NATHAN CLIFFORD

180 FALMOUTH STREET PORTLAND, MAINE

BID SET 2014_01-15

Reviewed for Code Compliance
 Inspectors Division
 Approved with Conditions

A1.05

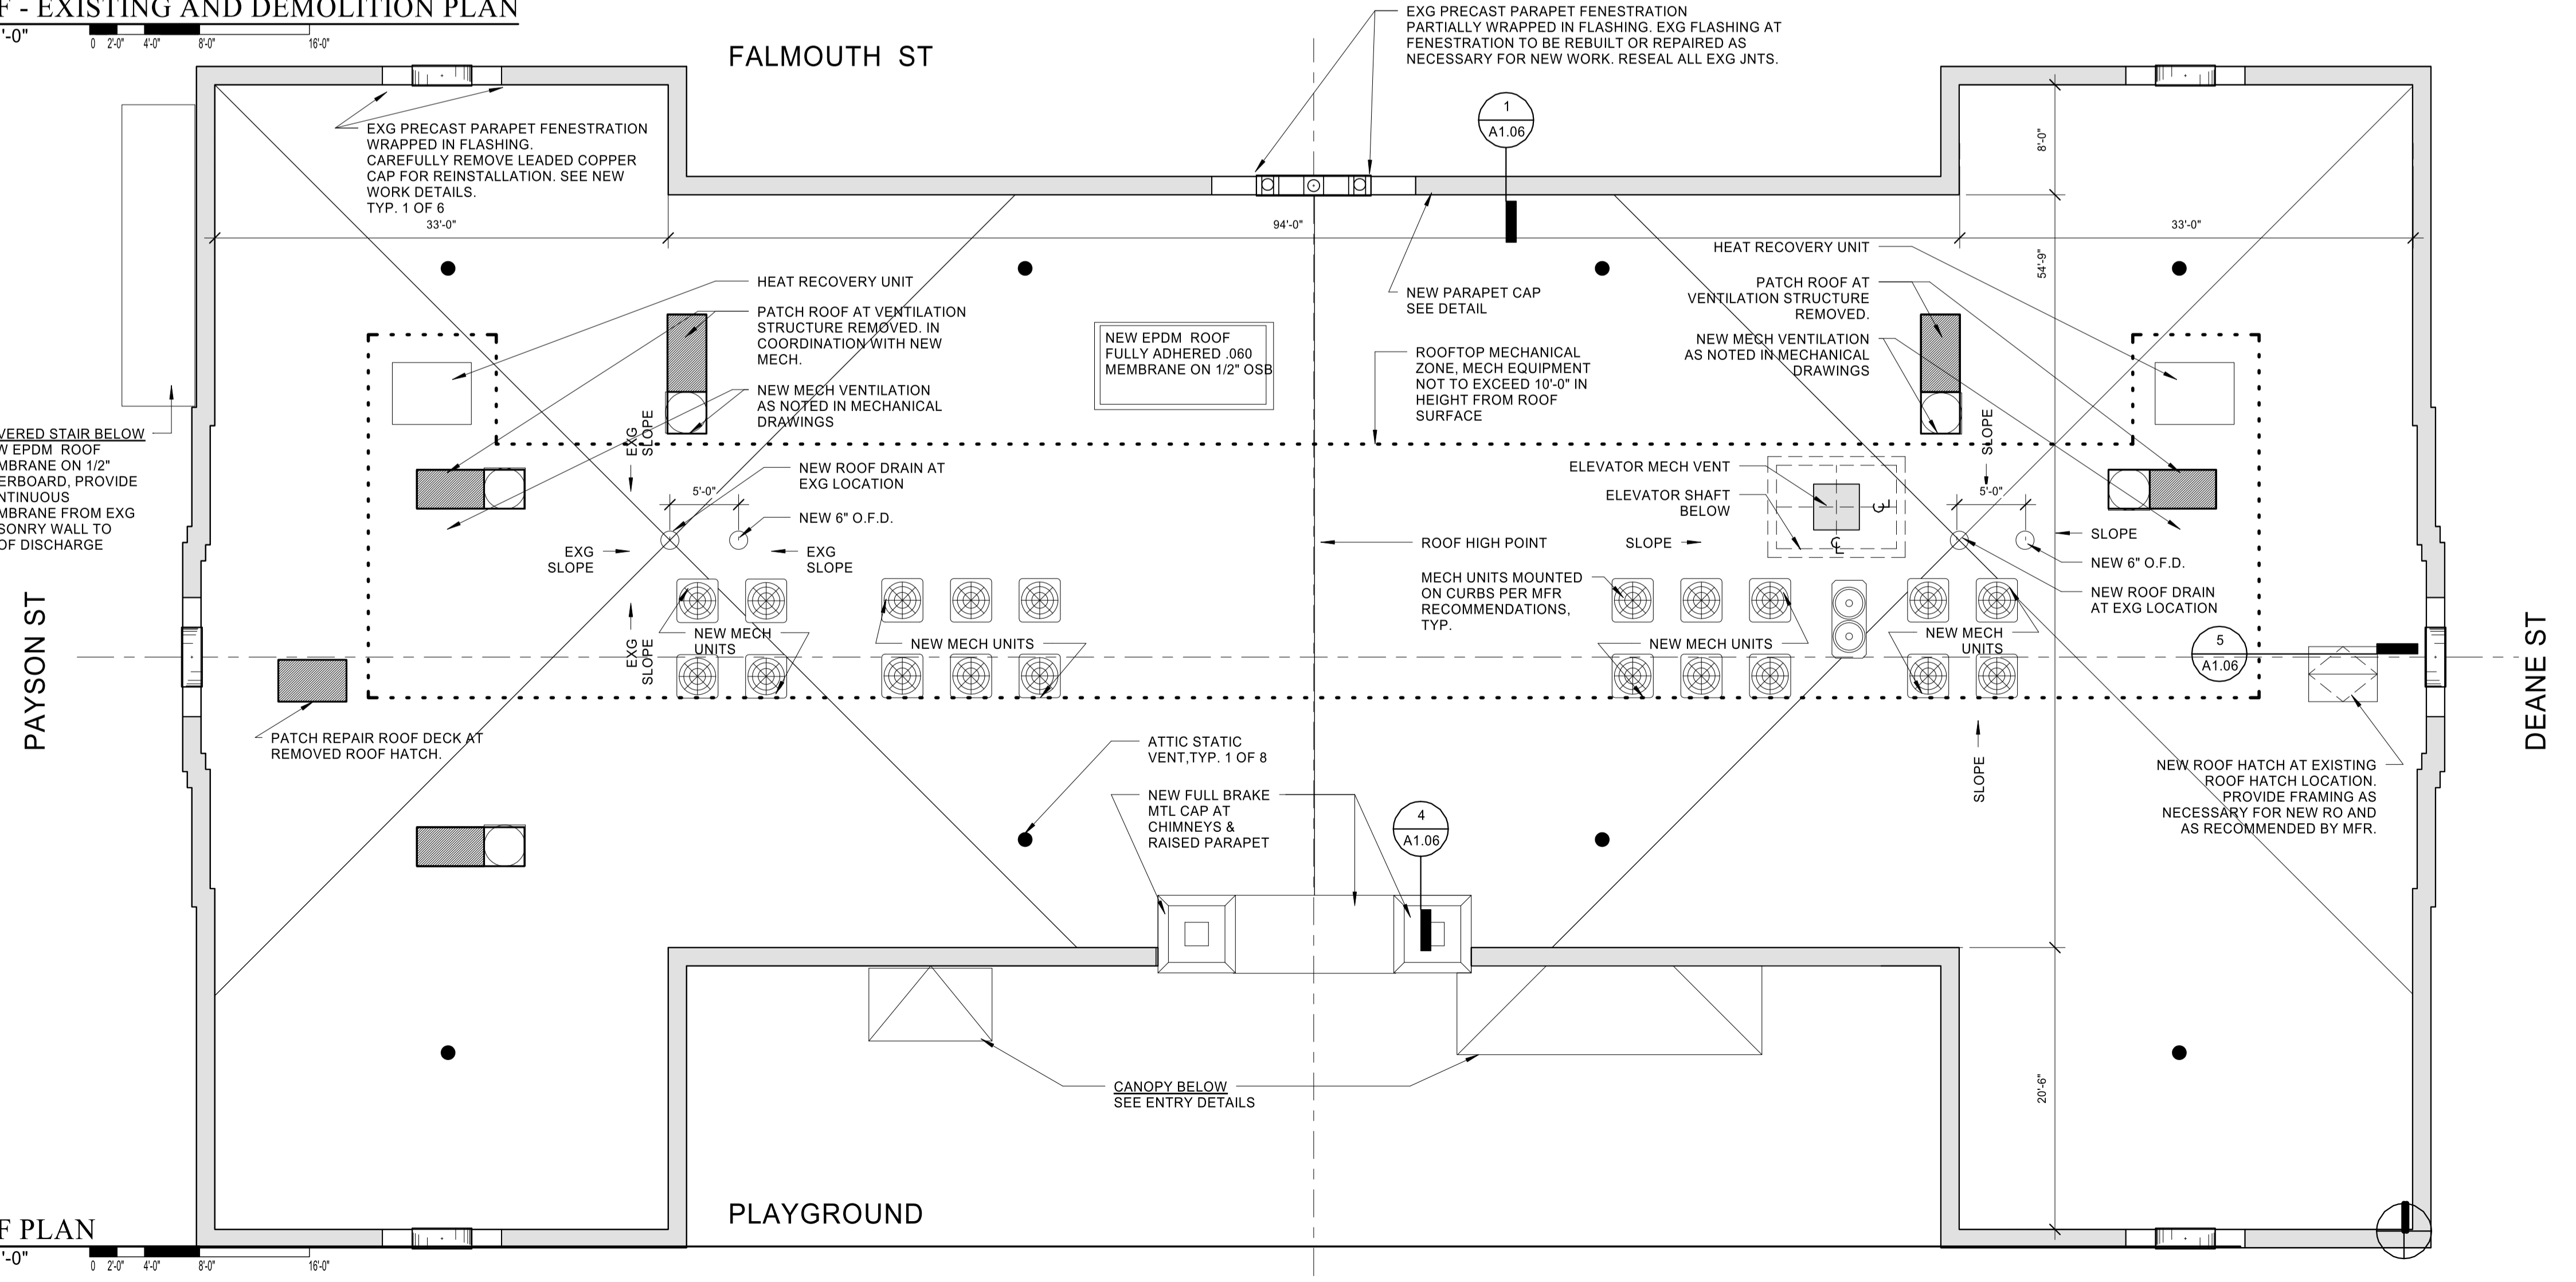
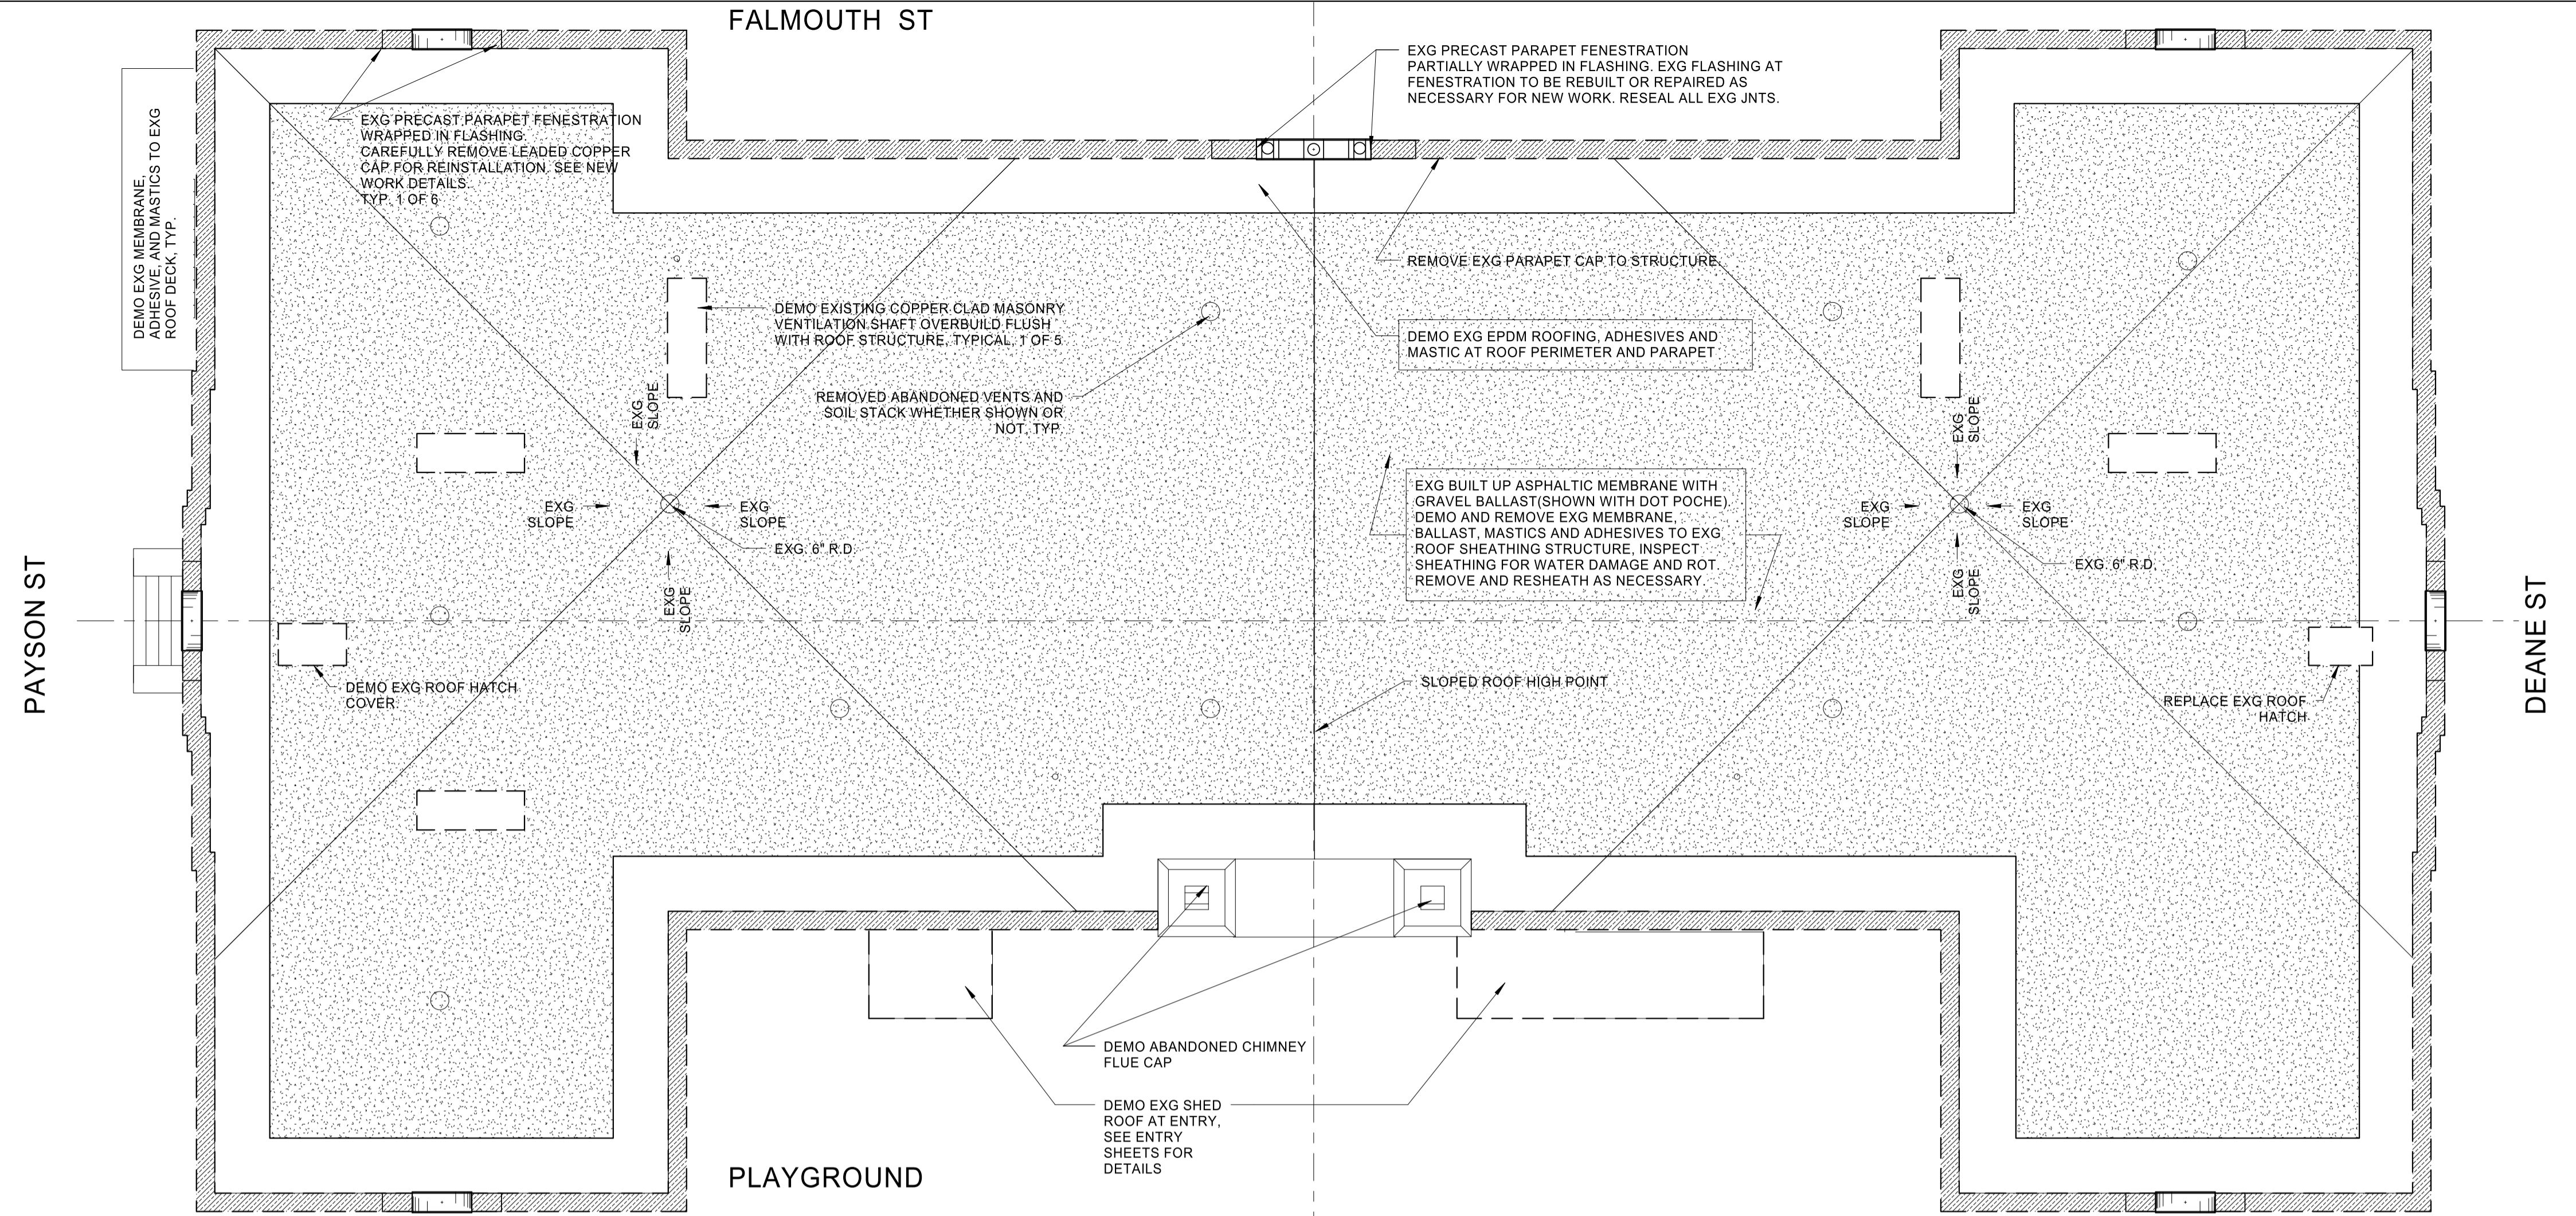
3. Comment digitally attached to “Roof Plan” on Page 1/A1.05 by Ms. Bourke:
